# ALERT SERVICE BULLETIN

**SUBJECT:** ELECTRICAL POWER - Generator Control Unit

Conversion of model 51530-021 EI MOD "C" to model 51530-022

### **ELECTRICAL POWER - GENERATOR CONTROL UNIT - CONVERSION OF MODEL 51530-021EI MOD "C" TO MODEL 51530-022**

Replacement Identification Plate

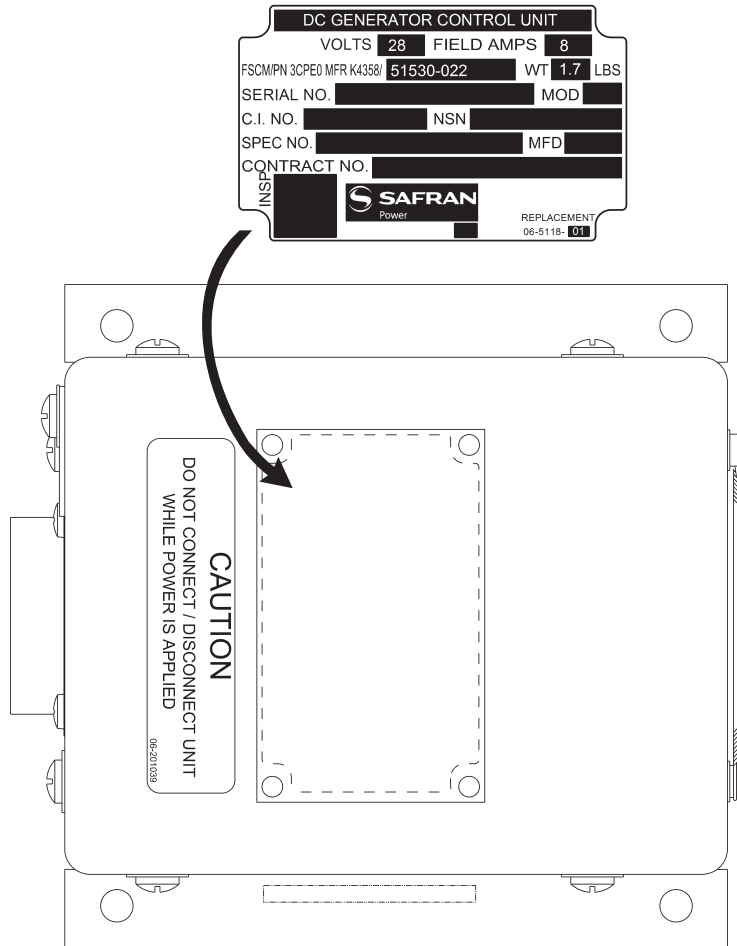
- (a) Record the serial number and manufacturing date from the existing nameplate.
- (b) Put the replacement identification plate (P/N 06-5118-01) on a wood backing surface and vibro-etch the recorded information from the old identification plate to the new replacement identification plate (P/N 06-5118-01) as shown in (Ref. Fig. 1).

- (c) After the serial number has been transferred, vibro-etch the applicable suffix as follows:
  - 1 If the model had been a 51530-021EI with a suffix "/CA" after the serial number, then suffix "/2CAA" must be added to the serial number on the 51530-022 nameplate.
  - 2 If the model had been a 51530-021EI with no suffix after the serial number, then the suffix "/CA" must be added to the serial number on the 51530-022 nameplate.
- (d) Do not transfer "MOD" information or inspection (INSP) information from the old identification plate.

VIBRO-ETCH "1/2CAA" OR "1/CA"  
AFTER THE SERIAL NUMBER  
AS REQUIRED

NOTE: THE SERIAL NO. AND MANUFACTURE DATE (MFD) MUST BE TRANSFERRED  
FROM OLD ID. PLATE.

NOTE: DO NOT TRANSFER "MOD" STATUS AND "INSP" INFORMATION FROM OLD ID. PLATE.
